**GULF STATES UTILITIES COMPANY**

February 6, 1985  
RBG- 20,086  
File No. G9.5, G9.23,  
G9.8.6.2

River Bend Station - Unit 1  
Docket No. 50-458

Enclosed are revisions to the River Bend Station Final Safety Analysis Report for your information. Attachment 2 supplements and/or revises my letter of November 29, 1984 (RBG-19,576) on this subject. These revisions support previous discussions with your staff and will be appropriately included in a future FSAR amendment.

DOCUMENT USER  
CONSULT E&DCR/N&D  
LISTING FOR CHANGES

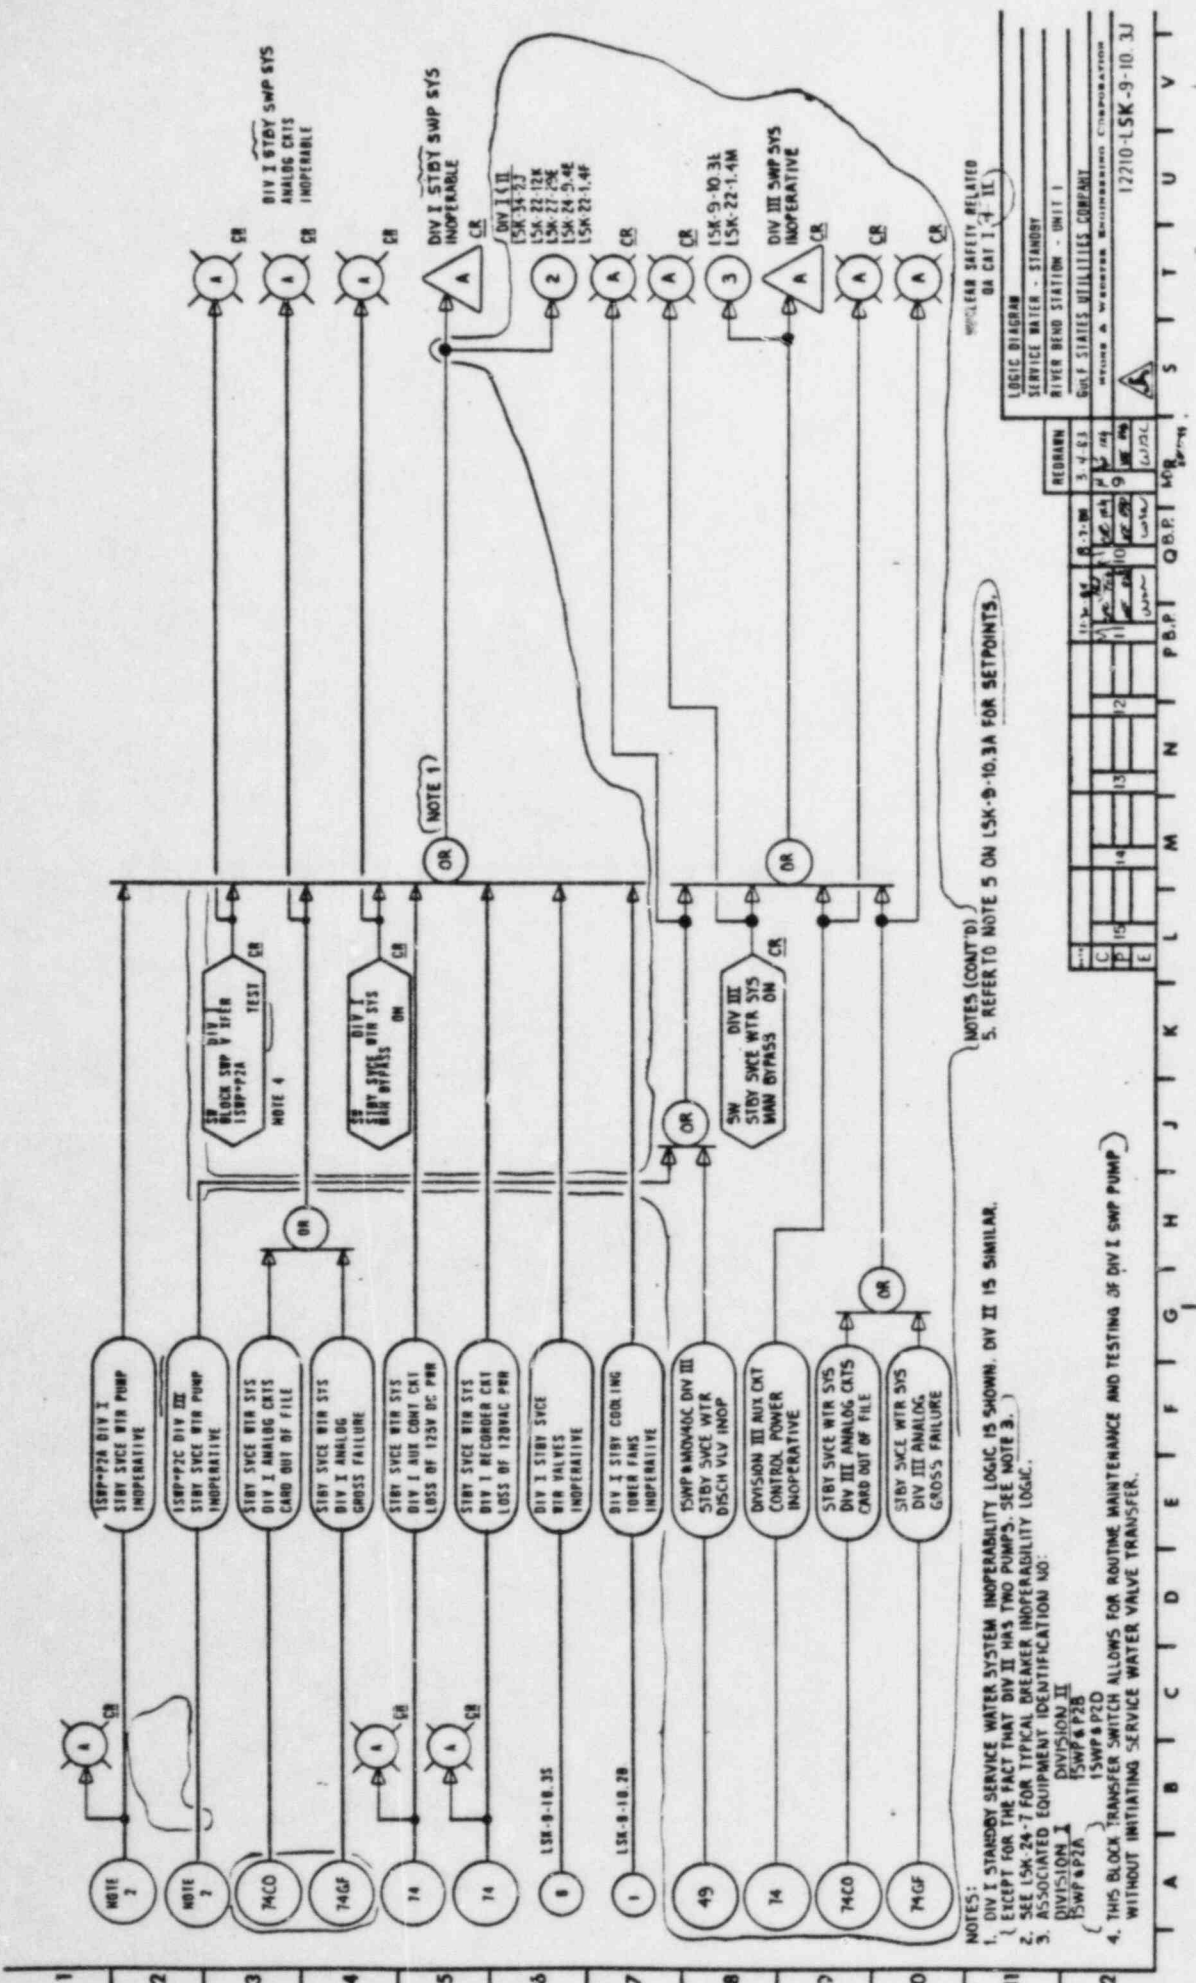
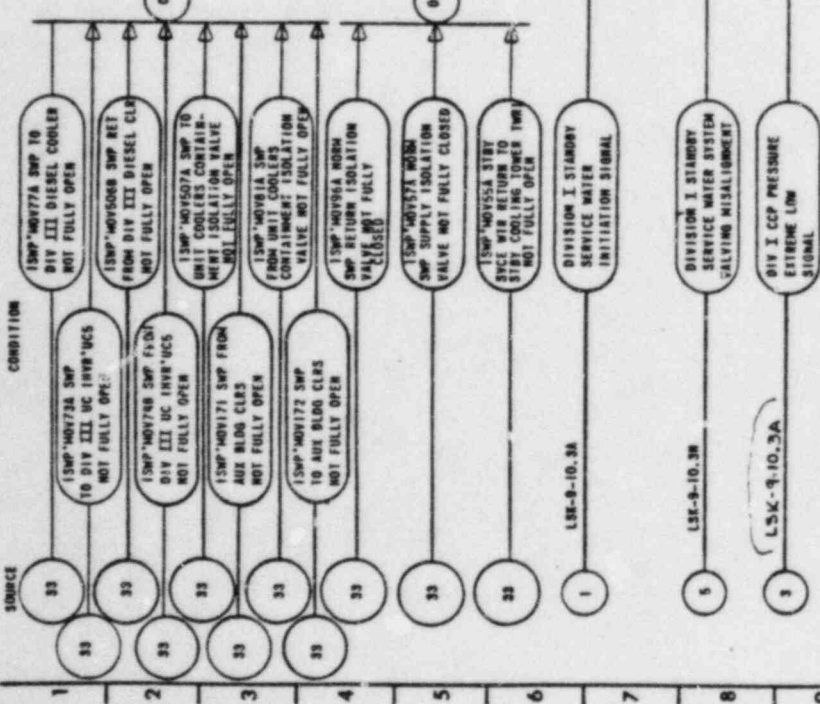
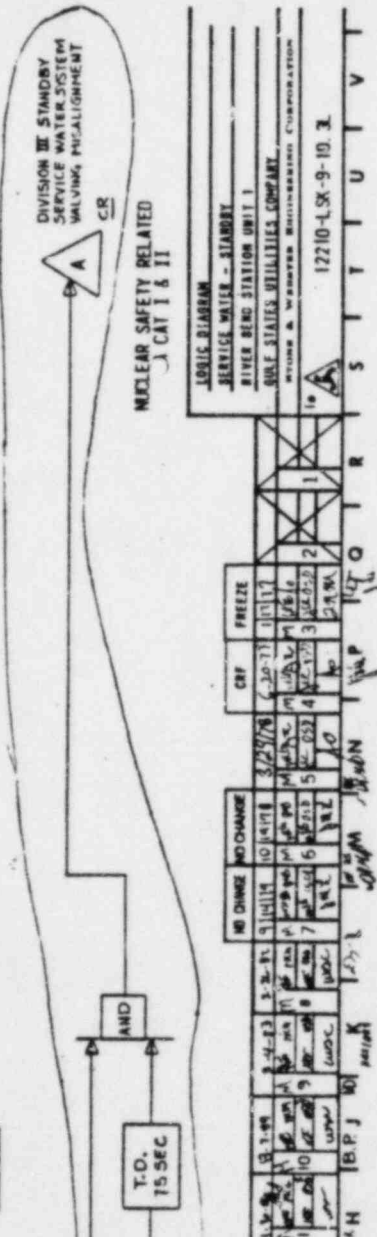
will be updated to reflect the attached LSK's.

FSAR Figure 7.3-11  
Sheet 13

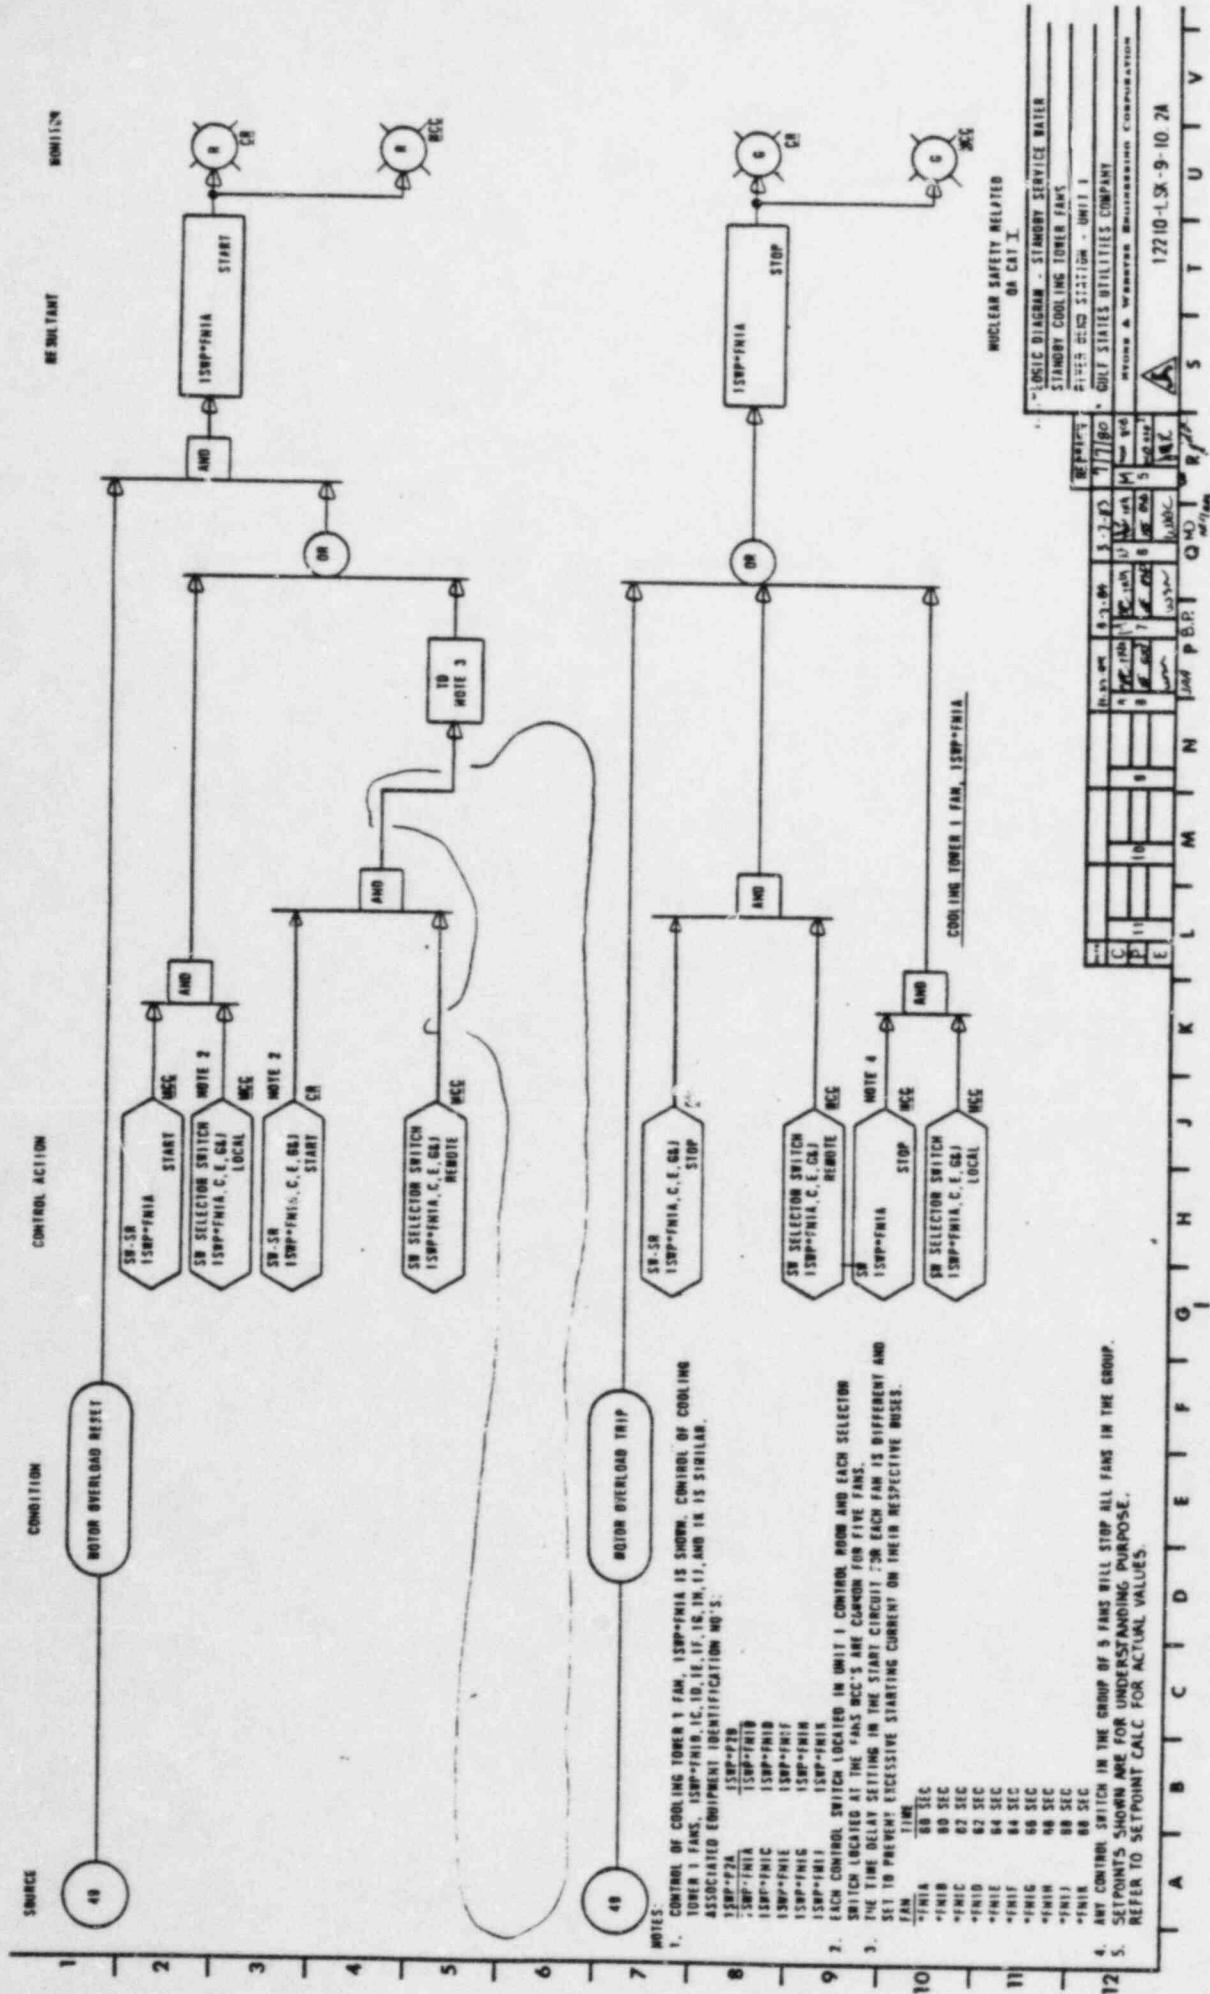
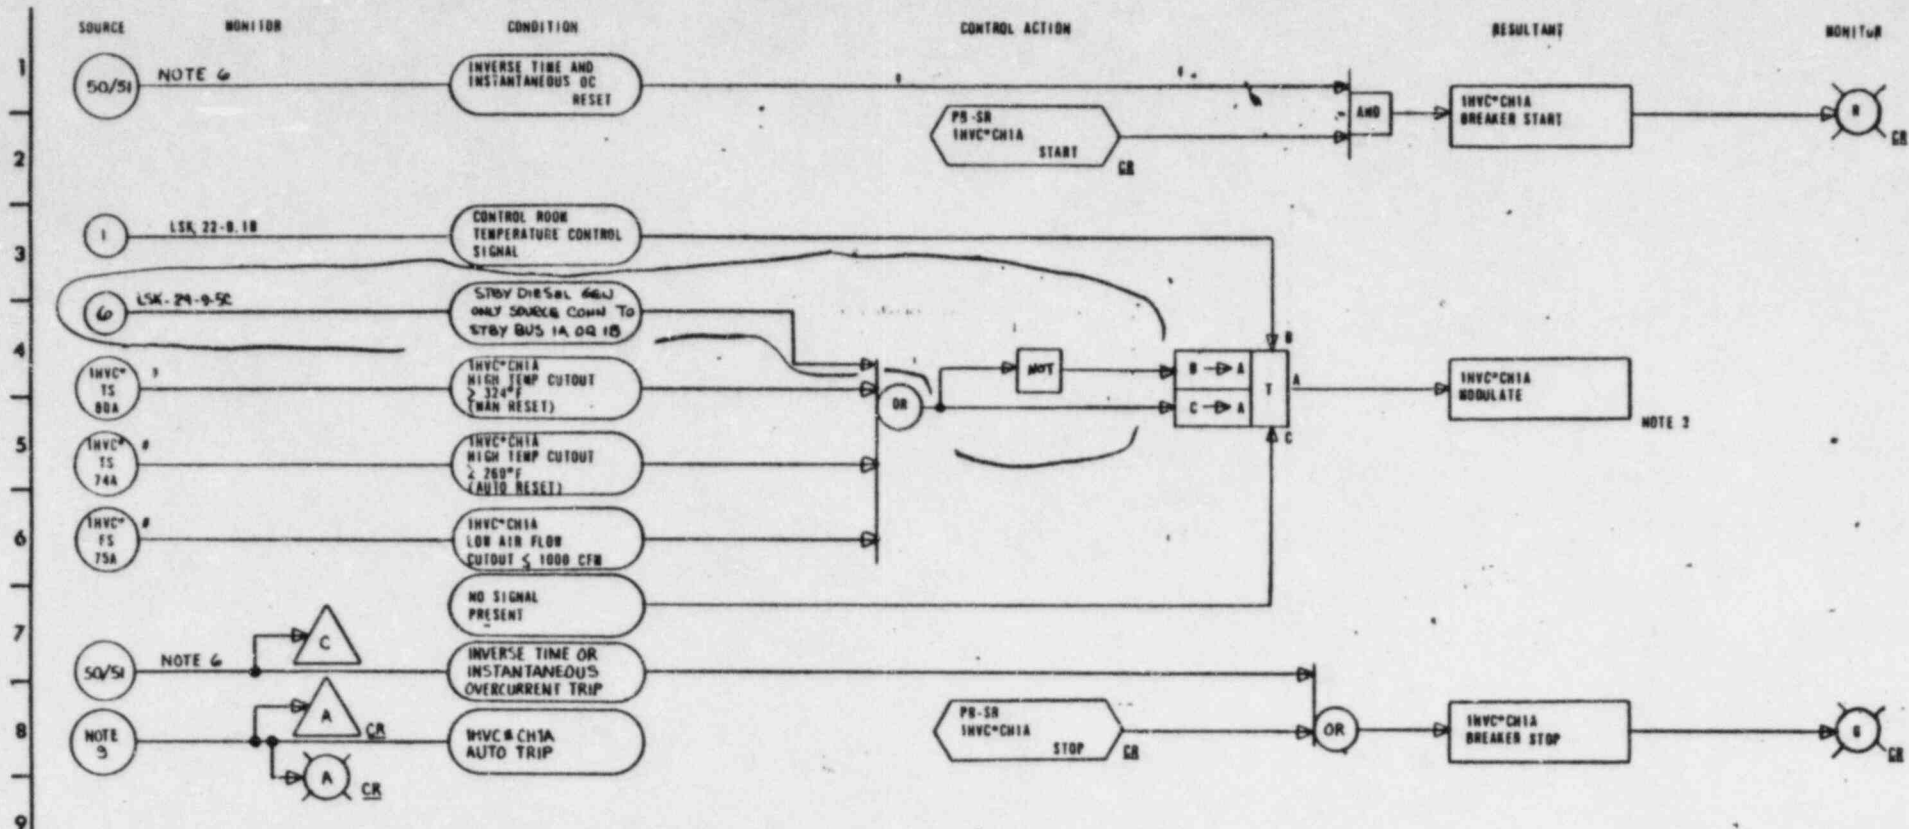
will be updated to reflect the attached LSK's.

FSAR Figure 7.3-12  
Sheet 3

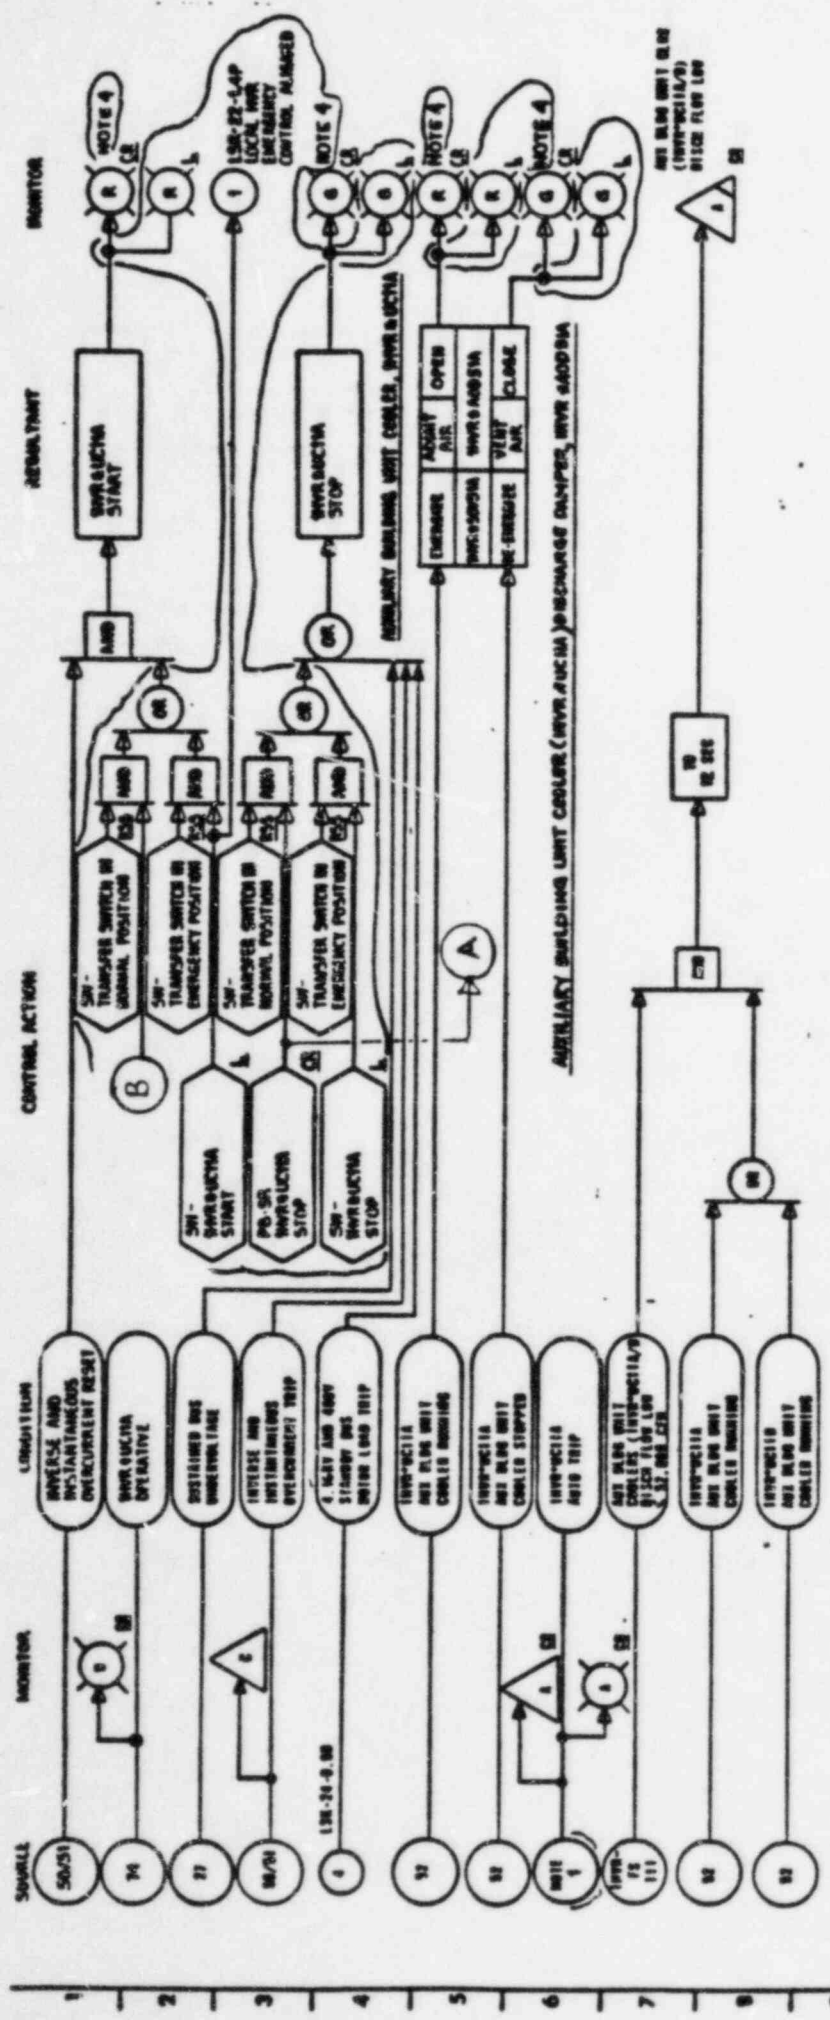
will be updated to reflect the attached LSK's.

FSAR Figure 7.3-14  
Sheet 5

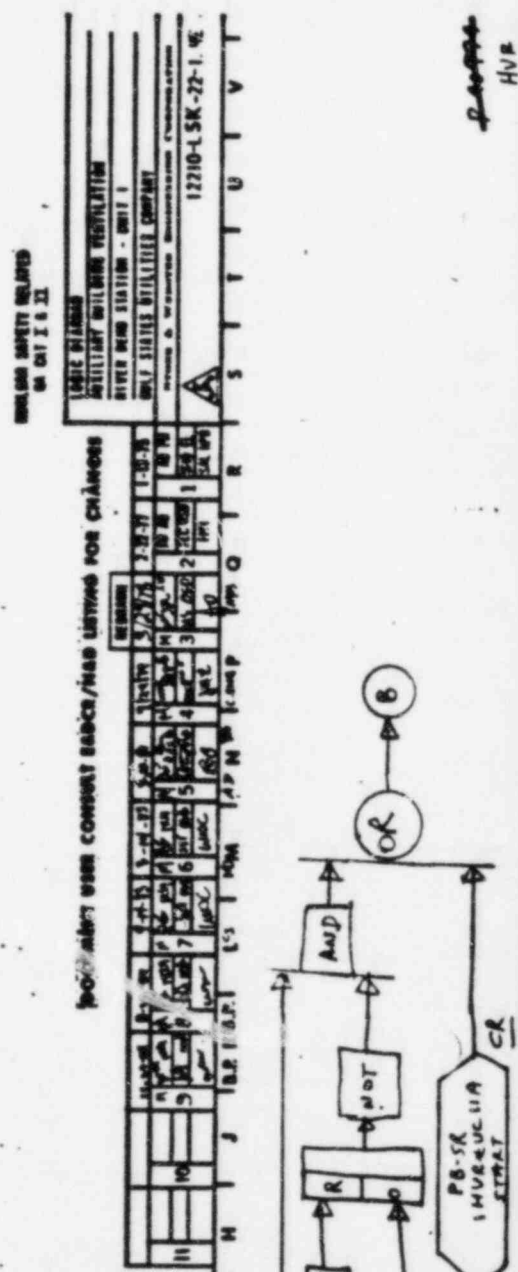
will be updated to reflect the attached LSK's.
